Staff Technical Position on Regulatory Considerations in the Design and Construction of the Exploratory Shaft Facility

U.S. Nuclear Regulatory Commission

Manuscript Completed: April 1991
Date Published: July 1991

FIGURE 1 -- An example of an acceptable approach to achieve compliance of the ESF design with 10 CFR Part 60 requirements. Refer to the text in Section 4.0 (Technical Position No. 1) for a discussion of this approach.

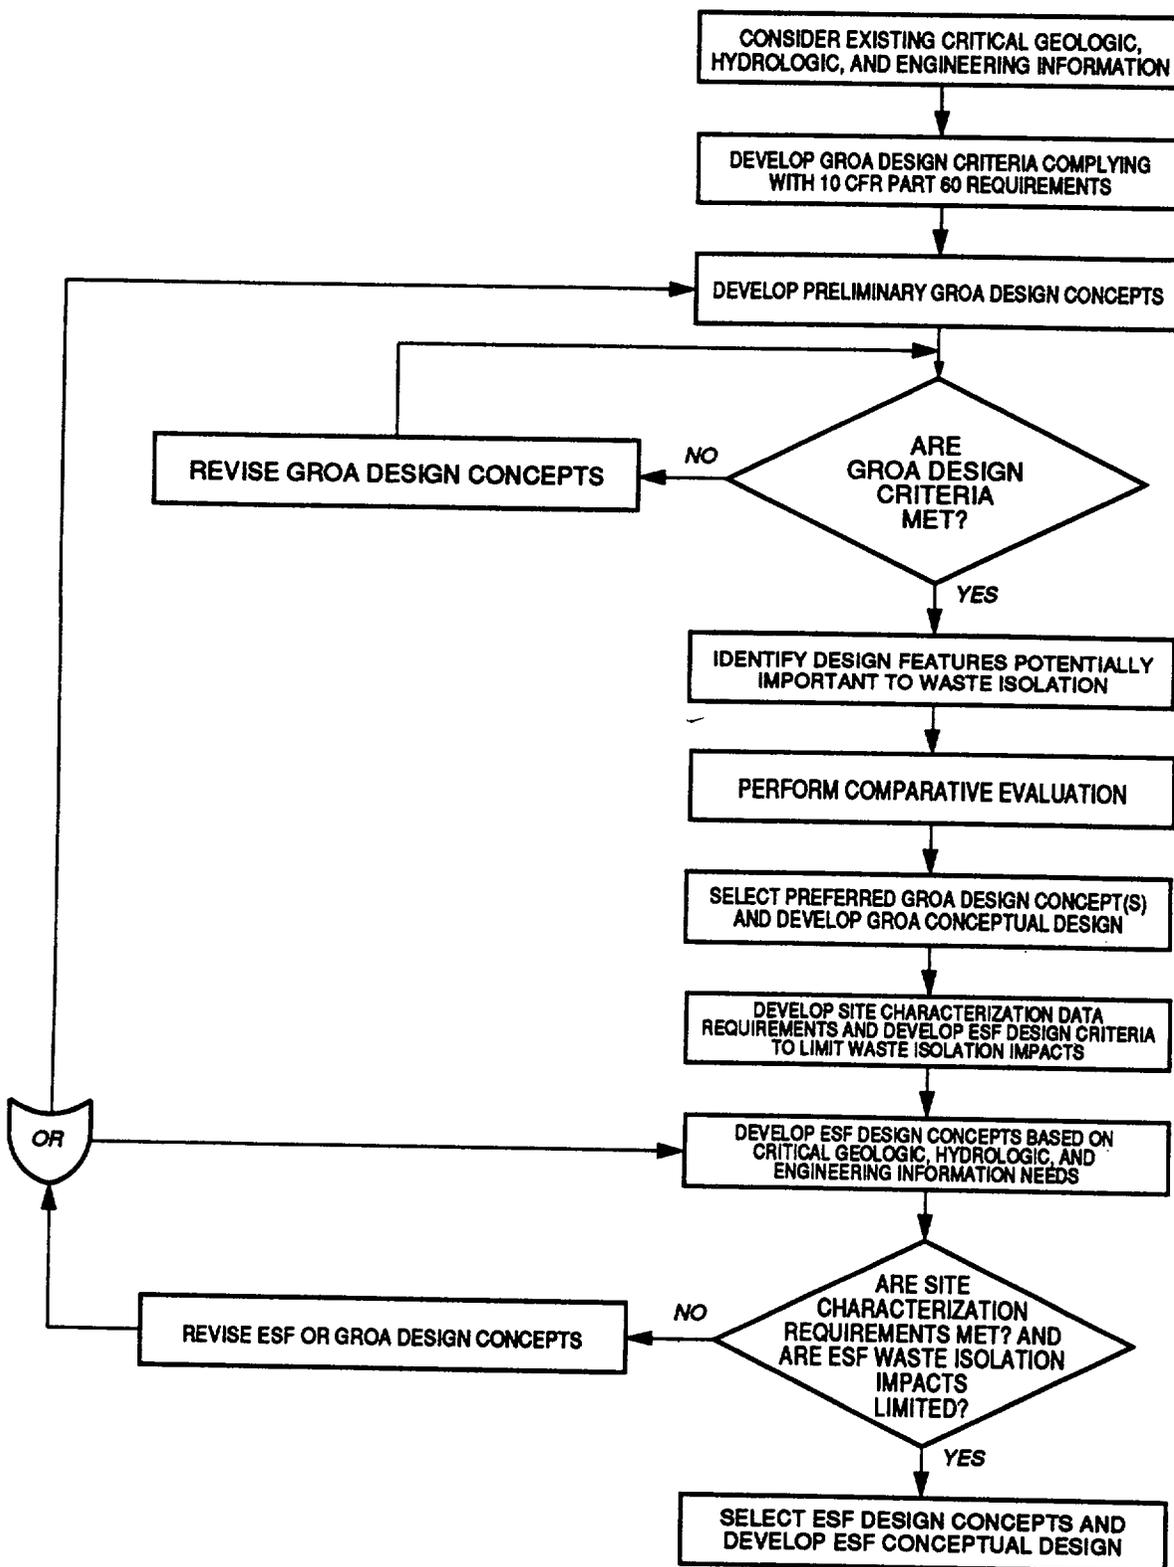
Figure 1 of the TP also introduces the concept of "minimizing" waste isolation impacts, which we believe is beyond the intent of the regulations. 10 CFR 60.15(c)(1) indicates that such impacts should be limited "to the extent practical," which implies that they be acceptable. The revised Figure 1 [Figure D1] also provides recommended changes to this.

This statement, as well as Figure 1, implies that a GROA conceptual design has not yet been developed by DOE. In fact, the SCP includes a GROA conceptual design as required by the NWPA and 10 CFR 60.17(c). See SCP, Vol. VI. Figure 1 provides a graphic confirmation of the inverted priority assigned by the TP to the purpose of the ESF by totally subordinating it to the GROA design. A more fundamental problem with Figure 1 is that it assumes the necessity for compliance of the ESF design with 10 CFR Part 60, when there is no basis for such an assumption.

Several other revisions suggested during our discussions with the NMSS staff include removal of wording in the STP that could be considered as adversarial, modification of the flow chart presented in Figure 1, and expansion of Item (7) (Establishment of Ranges of Site Parameters) [in Section 3.0].

Why doesn't Figure 1 reflect the statement in the STP that "In reality, we recognize that both efforts (ESF and repository (i.e., GROA) design) may well proceed simultaneously ..., " et cetera.

The staff agrees with the comment that the waste isolation impacts should be limited "to the extent practical" and they need not be minimized. However, should a design feature be acceptable and, based on existing information, an alternative to this feature is known to have significant advantages, the alternative design feature should not be dismissed merely because the original design feature was acceptable. In this context, the staff has revised the phrase in the process block in Figure 1 reading "Develop ESF Design Criteria to Minimize Waste Isolation Impacts" with the phrase "...Develop ESF Design Criteria to Limit Waste Isolation Impacts."

Also, in the same figure, the process block reading "ESF Waste Isolation Impacts Minimized and Site Characterization Requirements Met?" now reads "Are Site Characterization Requirements Met? and Are ESF Waste Isolation Impacts Limited?" The discussion (in Section 4.0) behind Technical Position No. 1, has been revised accordingly, to track with these changes.

As regards the ACNW's comments on the modification of the flow chart presented in Figure 1, the staff has modified the figure and the text in Item (1) of Section 4.0, accordingly. Four ACNW-recommended changes were made to Figure 1: (1) The addition of a new process block entitled "Consider Existing Critical Geologic, Hydrologic, and Engineering Information" at the beginning of the example approach; (2) changing of the title of the process block entitled "Develop ESF Design Concepts" to "Develop ESF Design Concepts Based on Critical Geologic, Hydrologic, and Engineering Information Needs"; (3) the connection of the two process blocks entitled "Revise ESF or GROA Design Concepts" and "Develop Preliminary GROA Design Concepts" by an activity line (through an "Or" gate); and (4) the shifting of an activity line from the "Revise ESF or GROA Design Concepts" process block to a new position (through an "Or" gate) as input to the process block entitled "Develop ESF Design Concepts" from an original position that was between "Develop ESF Design Concepts" process block and the decision block entitled, "Are Site Characterization Requirements Met? and Are ESF Waste Isolation Impacts Limited?"

This comment is noted. The staff considers that although it is possible to proceed with the design of the ESF and the GROA simultaneously, this approach is not likely to be used. Therefore, Figure 1 does not reflect this approach. However, the approach shown in Figure 1 is only one of the acceptable ways DOE can proceed with the ESF design process. It does not preclude DOE from using other possible acceptable approaches.
